PRELIMINARY DRAINAGE REPORT

CATTLETRAK TRUE HOMES (Case No 19-ZN-2016)

PROJECT NAME: 19-ZN-2016 CATTLETRACK VILLAGE

DRAINAGE COMMENTS / DRAIN:

SECTION A-A
 SCALE H: 1"=20'
 SCALE V: 1"=2'

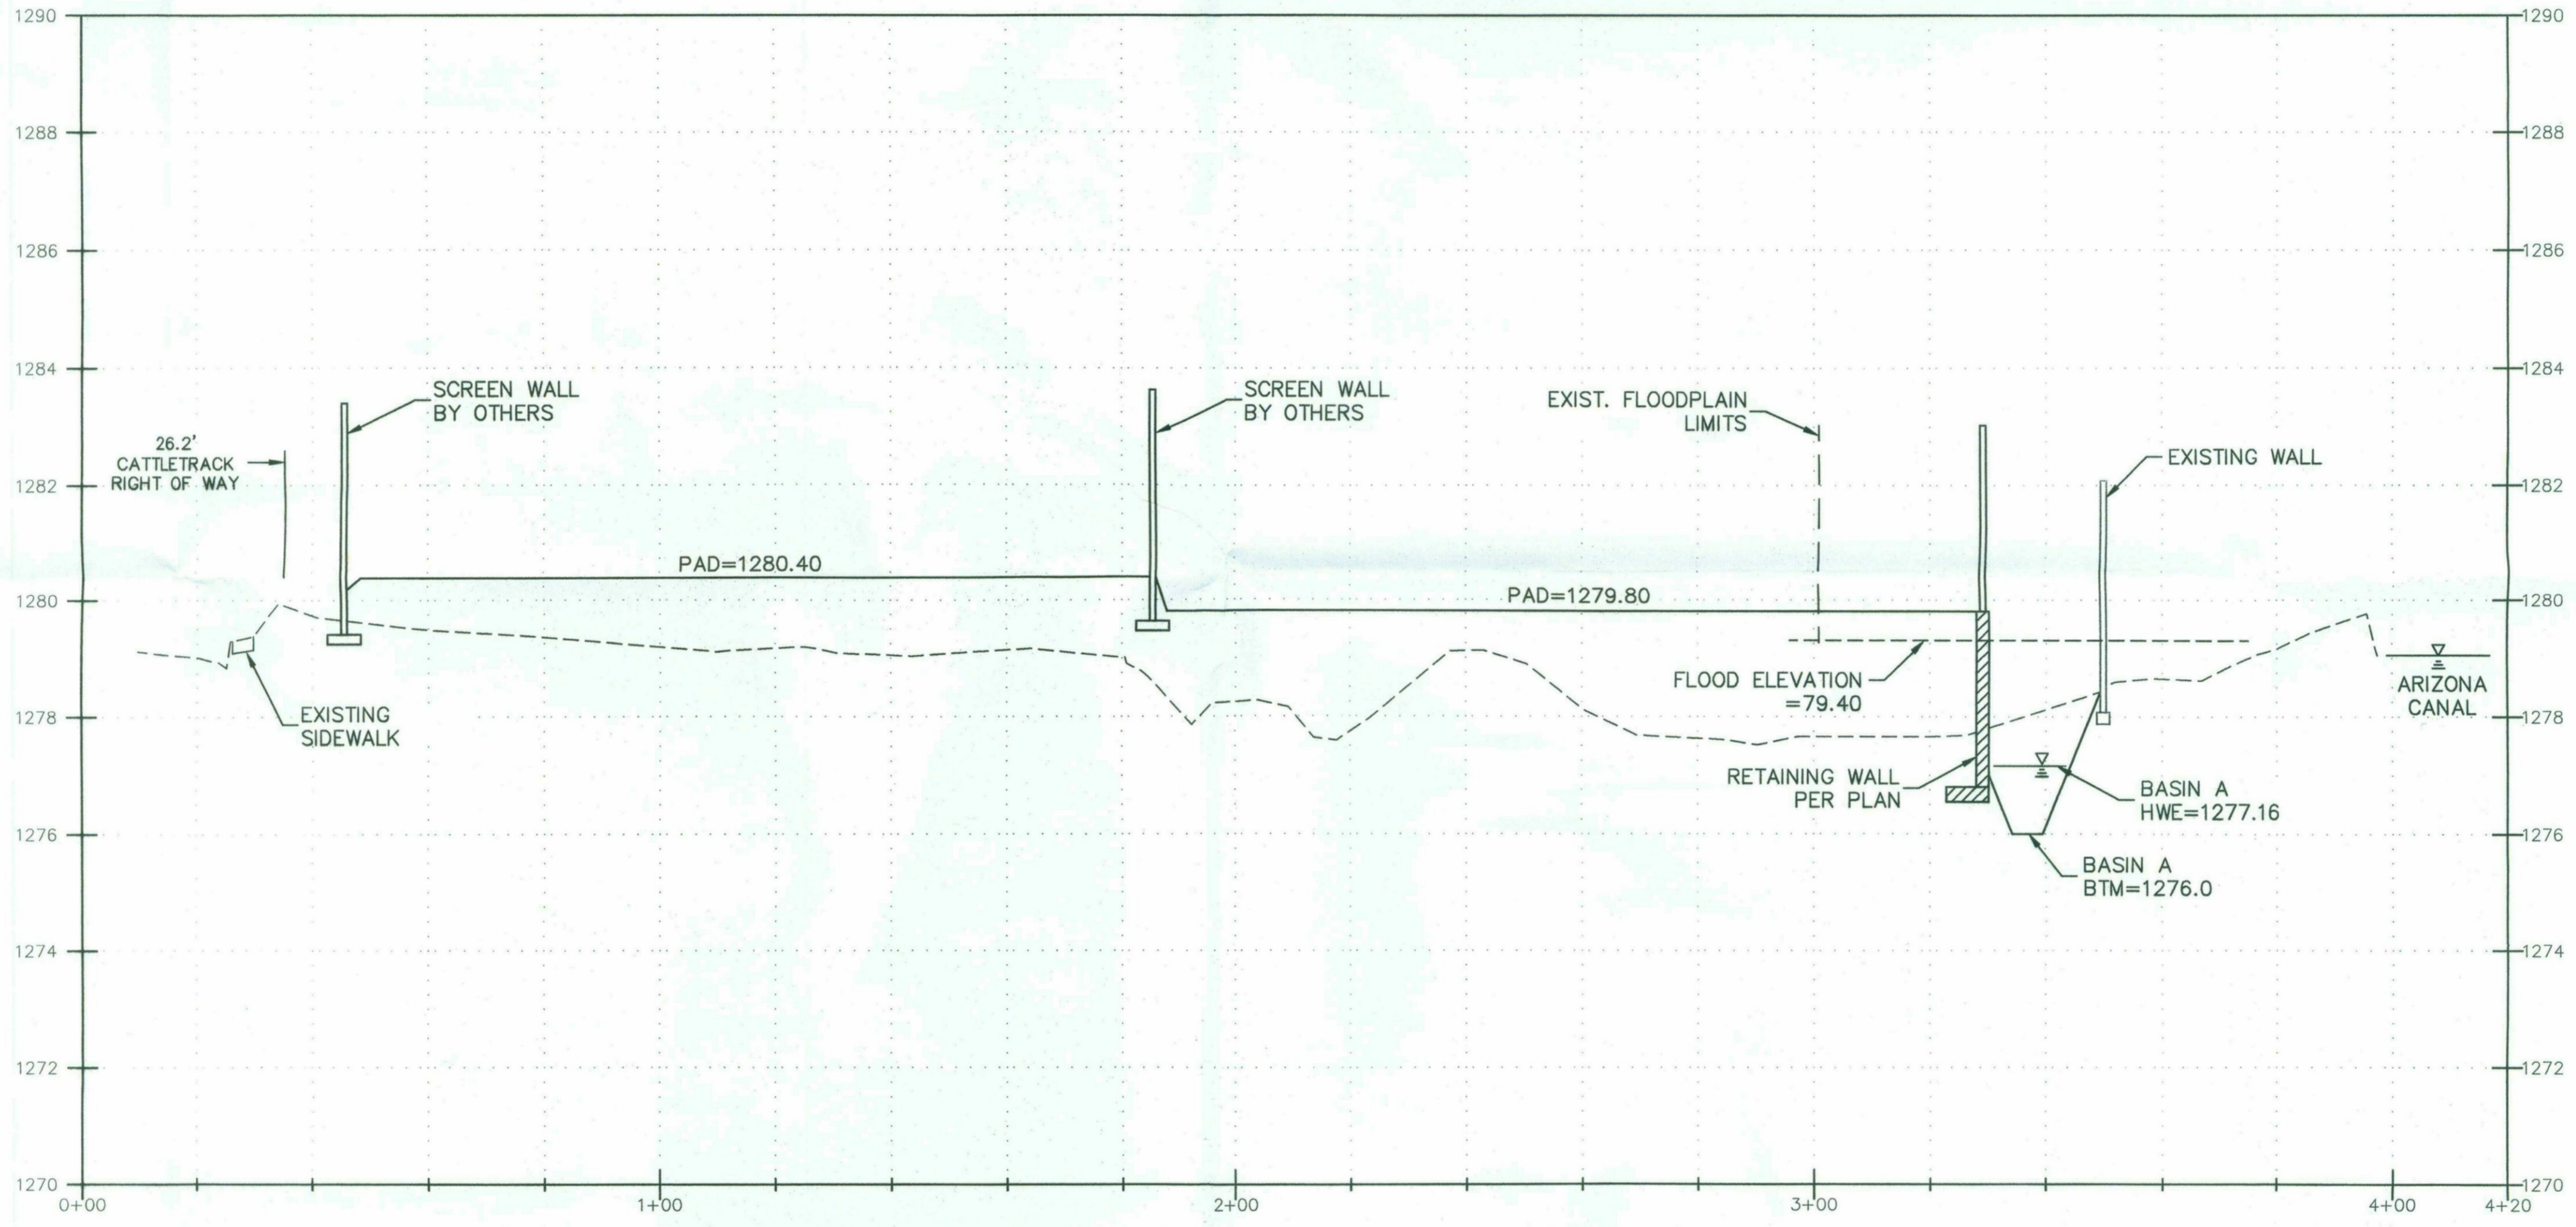
14. Calculate the compensatory storage volumes for flood zone AH areas and compare it to the compensatory storage volume for flood zone A areas. Provide a typical cross section full size sheet across the site with the Flood Zone AH, similar to the full size sheet for Section A-A. 10/4/16
